SOUTH CAROLINA ELECTRIC & GAS COMPANY

May 16, 1972

RE: Virgil C. Summer Nuclear Station  
Docket No. 50-395

In response to your letter of May 2, 1972, we are submitting the attached answers to your questions. As you requested, forty-five (45) copies of the answers are submitted.

Figure 2SA.4-1

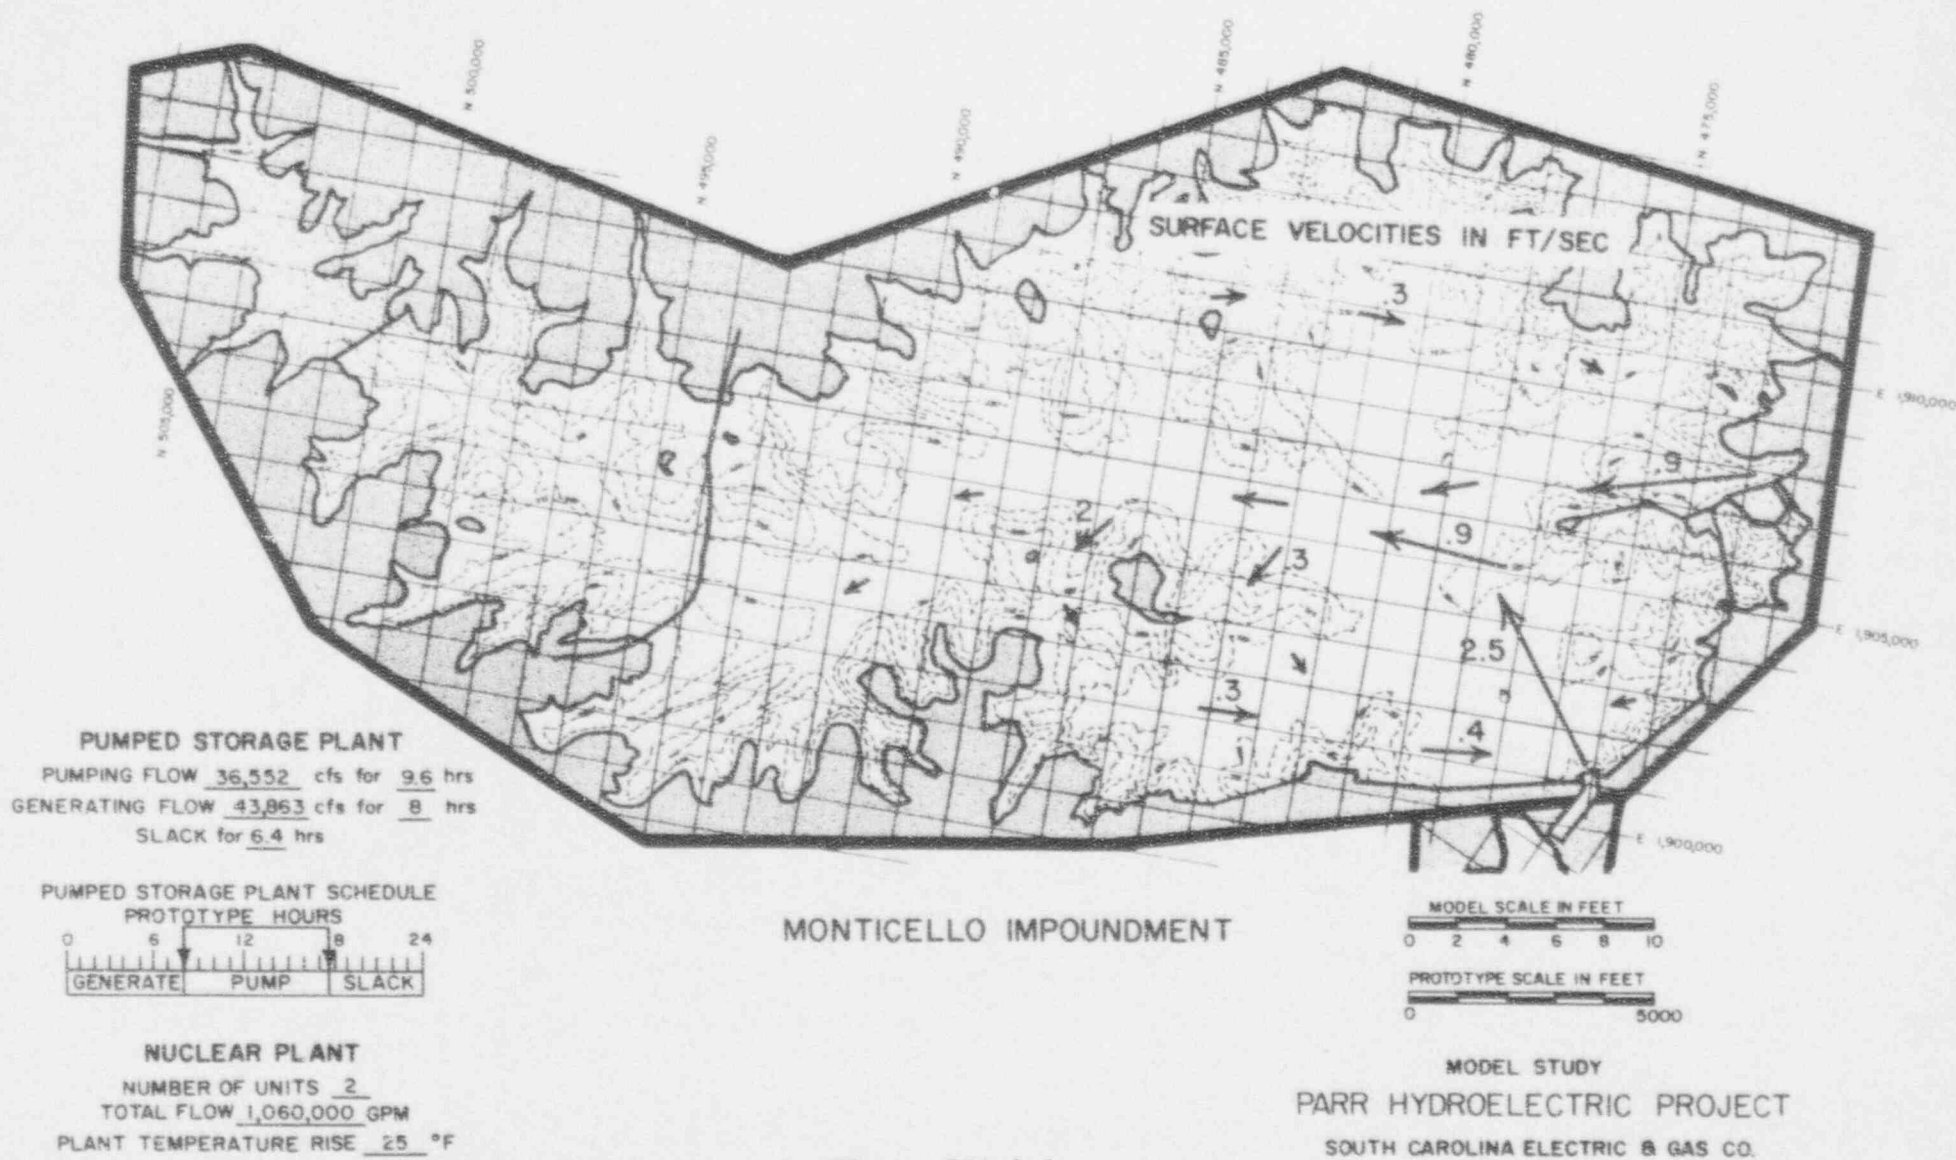
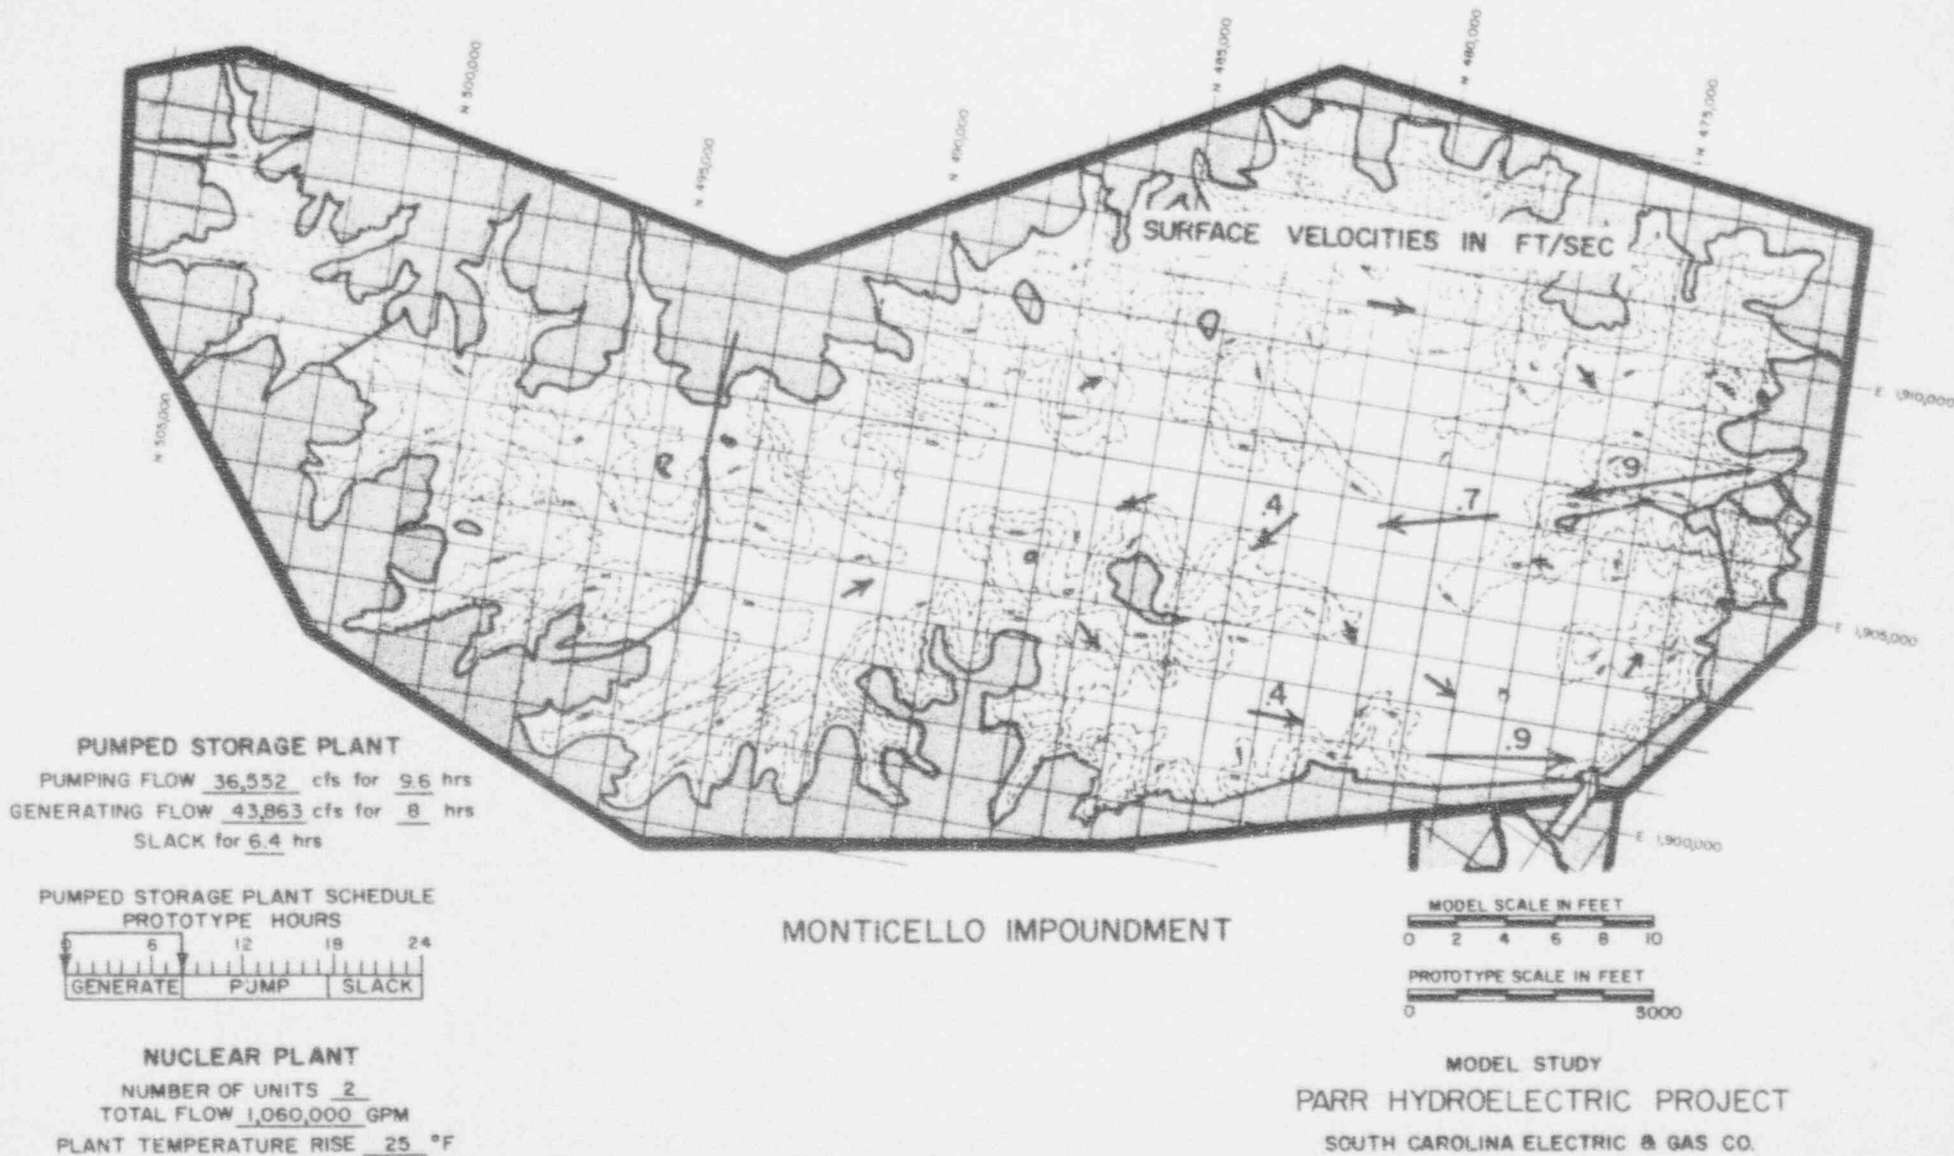
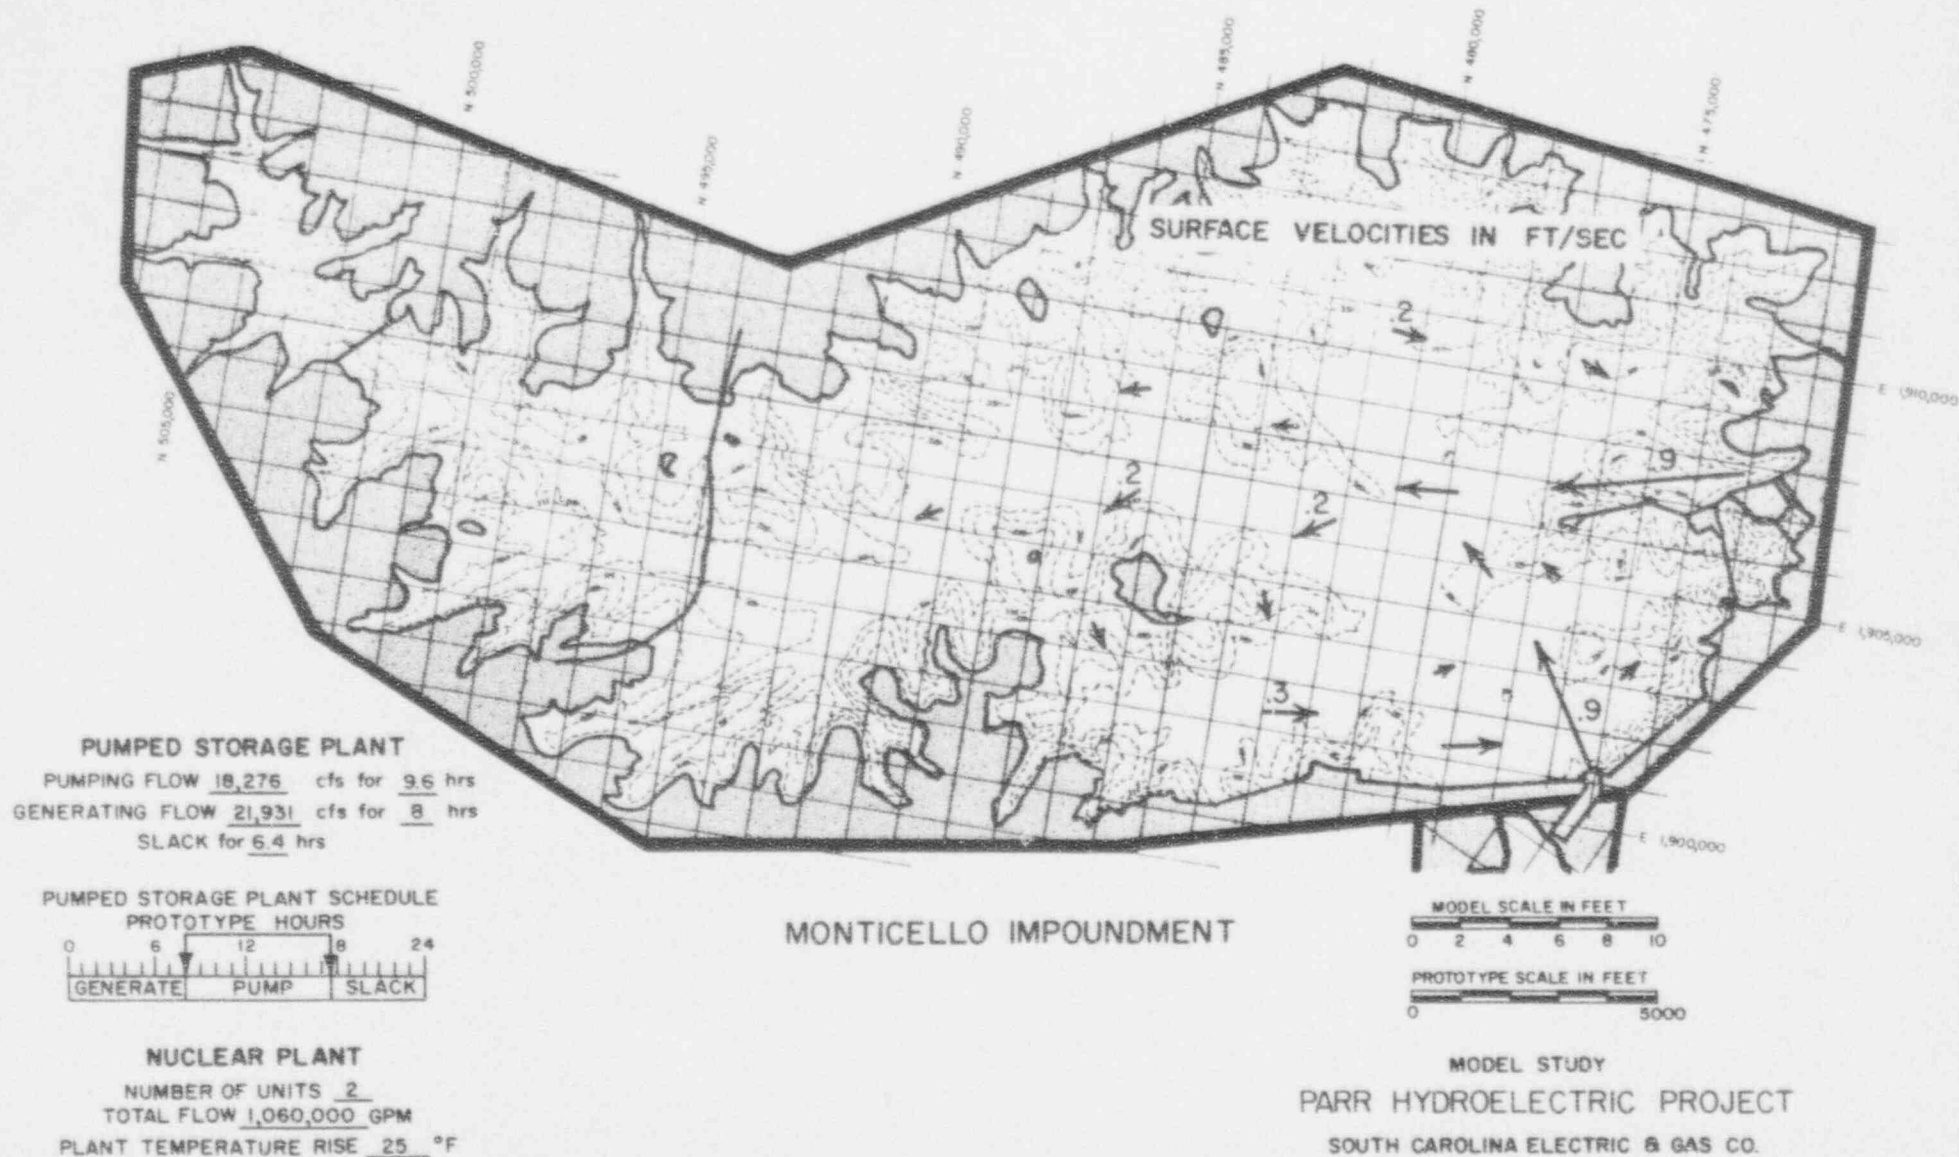
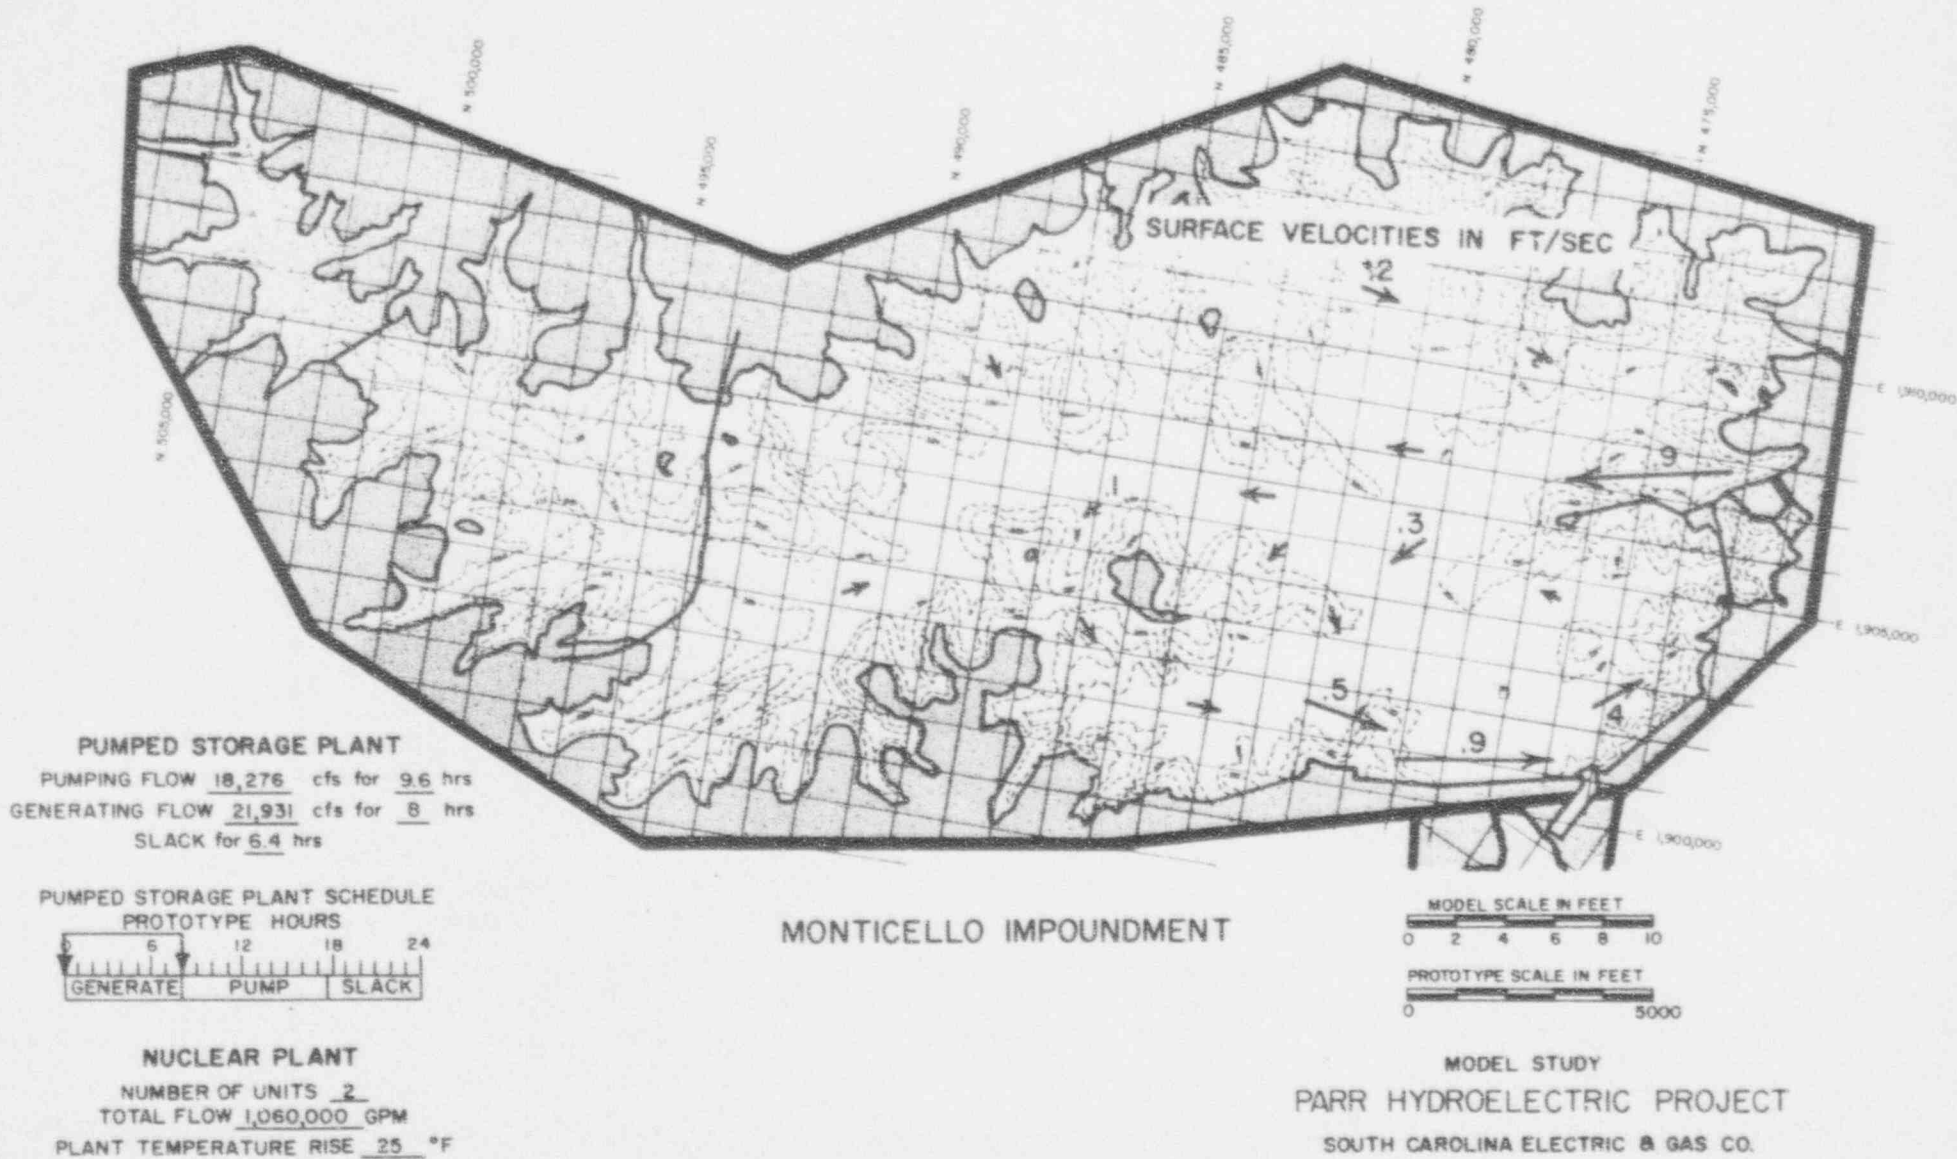
2SA.4 QUESTION: Provide data on the monthly maximum, minimum and average stream flows between the two water bodies and indicate how the outflow between the lake and the reservoir contributes to surface circulation of the lake.

South Carolina Electric & Gas Company expects the maximum monthly mean for stream flow between Monticello and Parr Reservoirs to be 11,973 CFS and to occur during the peak month of August. The minimum monthly mean stream flow will be approximately 5000 CFS and will occur in April. The monthly mean average flow is approximately 7000 CFS. The flow would be zero when the pumped storage plant is shut down.

Figures 2SA.4-1 and 2SA.4-2 show the surface circulation in the Monticello Impoundment when the pumped storage plant is under full load, Figures 2SA.4-3 and 2SA.4-4 for the average plant load and Figure 2SA.4-5 when the pumped storage plant is shut down.
